Staff Report to the Zoning Administrator

Application Number: **121302**

Project Description: Proposal to demolish an existing 690 square foot nonconforming single family dwelling and to construct a two story, one bedroom, 1,620 square foot single family dwelling on a parcel in the R-1-6 zone district. Requires a Coastal Permit, Soils Report Review, Preliminary Grading Review, and a Categorical Exemption from the California Environmental Quality Act under Class 15303.

Location: Property located on the north side of Sunset Drive about 60 feet from the intersection of Sunset Drive and Mesa Way (65 Sunset Drive).

SITE PLAN

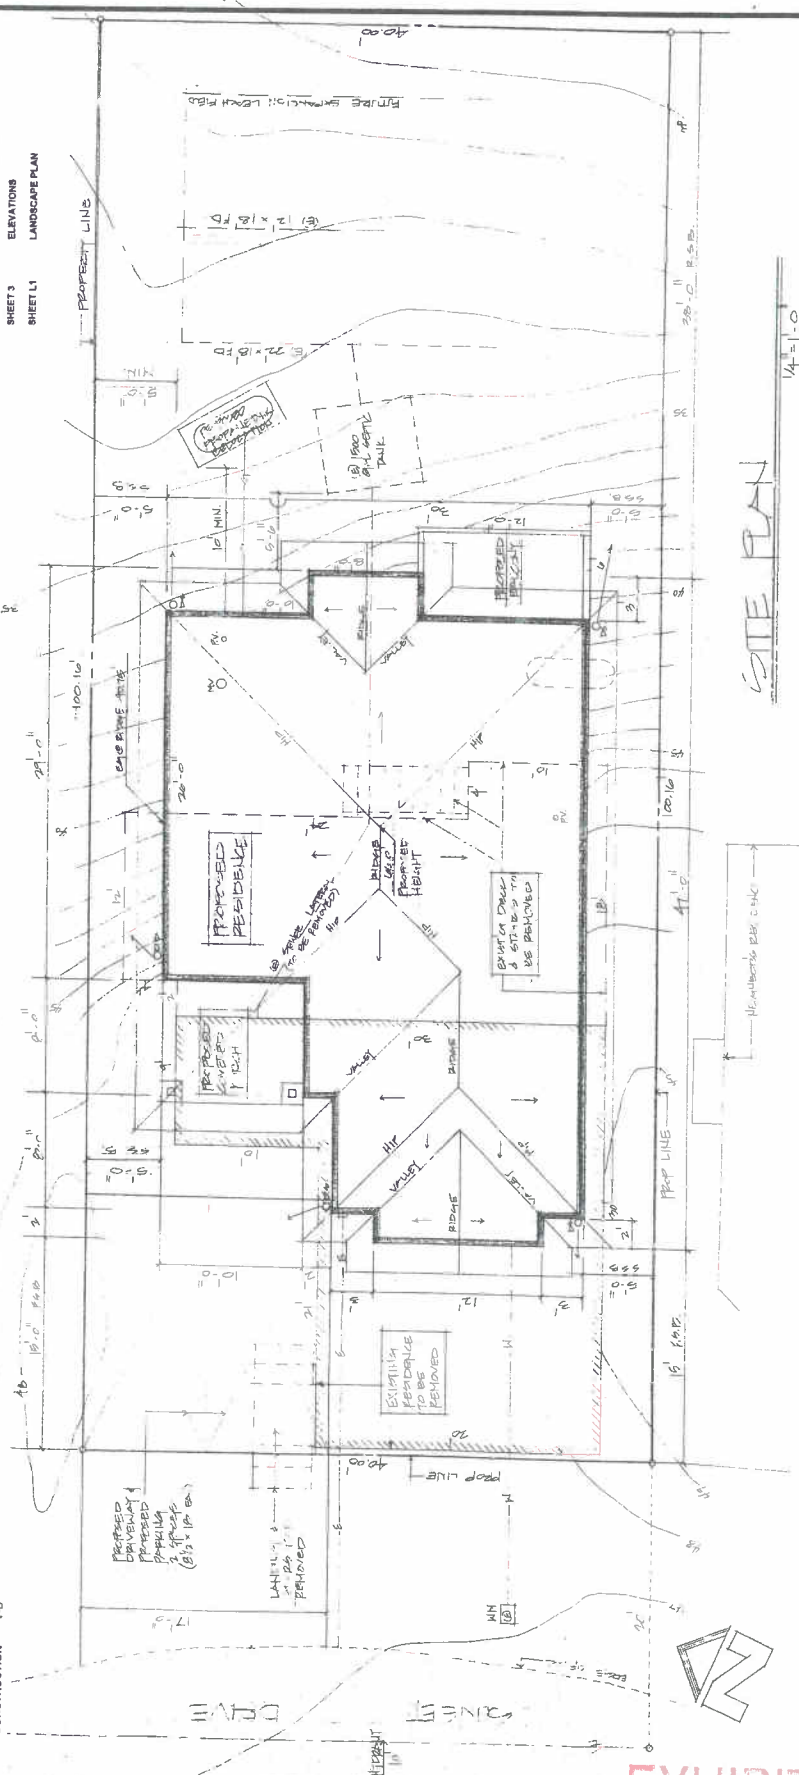
SHOW on the plans, **DETAILS** of compliance with the access road requirements. The access road shall be **18** feet minimum unobstructed width and maximum twenty percent slope. The access road fronting the project property corner to property corner shall conform to the minimum width standard.

The access road shall be widened to 18' or the existing turnaround shall be improved to meet the standards of Santa Cruz County Fire. If you have any questions regarding the requirements, contact Deputy Fire Marshal Chris Walters at the number listed above.
